UNITED STATES PATENT AND TRADEMARK OFFICE

Office Action Summary	Application No. 10/559,975	Applicant(s) CUNNINGHAM ET AL.	
	Examiner MICHAEL CARTON	Art Unit 4118

DETAILED ACTION

FIG 2

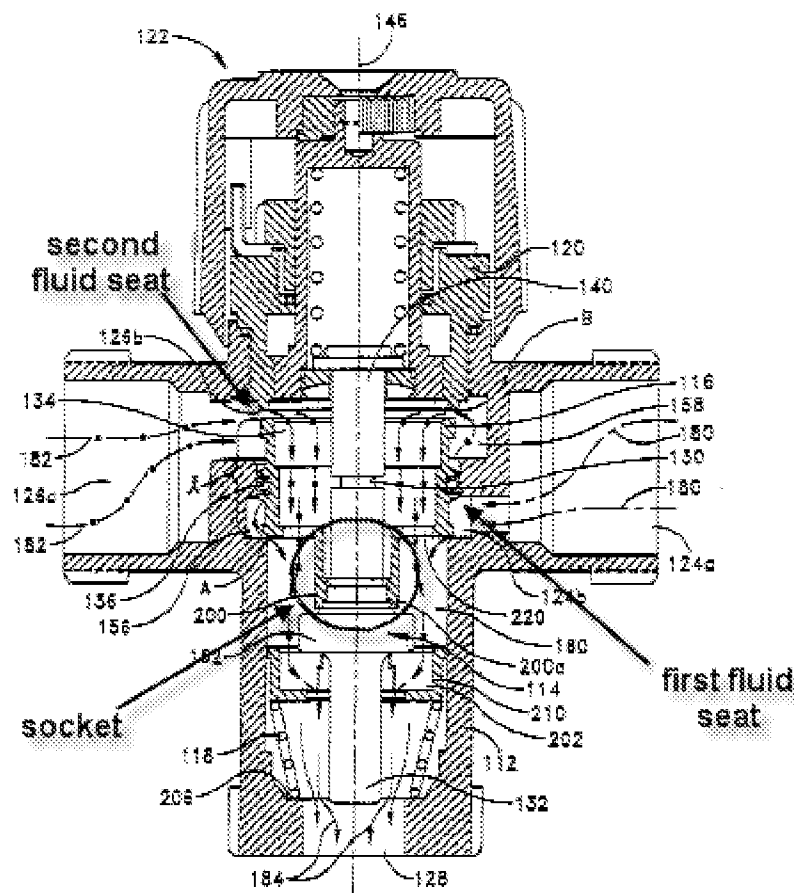
10. Regarding claim 1, Lebkuchner discloses a thermostatic mixing valve comprising a valve body 112 (fig 2), a first fluid inlet 124a (fig 2), a second fluid inlet 126a (fig 2), a fluid outlet 128 (fig 2) and a mixing chamber 160 (fig 2) located between the respective fluid inlets and fluid outlets, a thermostatic element 114 (fig 2), and a piston 130 (fig 2). This piston 130 (fig 2) also throttles the flow of the first fluid and the second fluid by varying its position relative to the respective fluid seats, as shown in fig 2 below, and described in column 2 lines 53-66.

11. Regarding claim 2, Lebkuchner further discloses a second fluid seat (fig 2 above) formed as an elongate portion extending in the direction of the movement of the actuator piston 130 (fig 2) allowing the piston 130 (fig 2) to slide along the elongate portion.

FIG 2

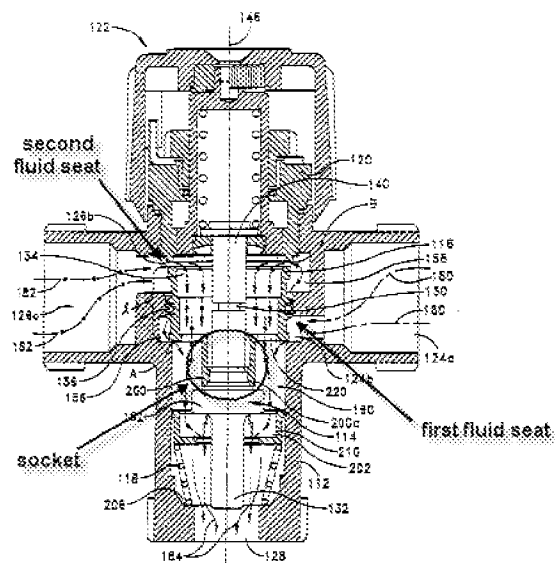
15. Regarding claim 8-9, Lebkuchner further discloses an adjustment mechanism 122 (fig 2) for adjusting the rest position of the thermostatic element (column 7 lines 42 – 46), the adjustment mechanism 122 (fig 2) is arranged to adjust the positioning of the thermostatic element relative to the piston so that a set temperature of the fluid through the fluid outlet 128 (fig 2) can be varied.

16. Regarding claim 10, Lebkuchner further discloses socket 200 (fig 2), wherein the piston 130 (fig 2) engages the thermal actuator 114 (fig 2).
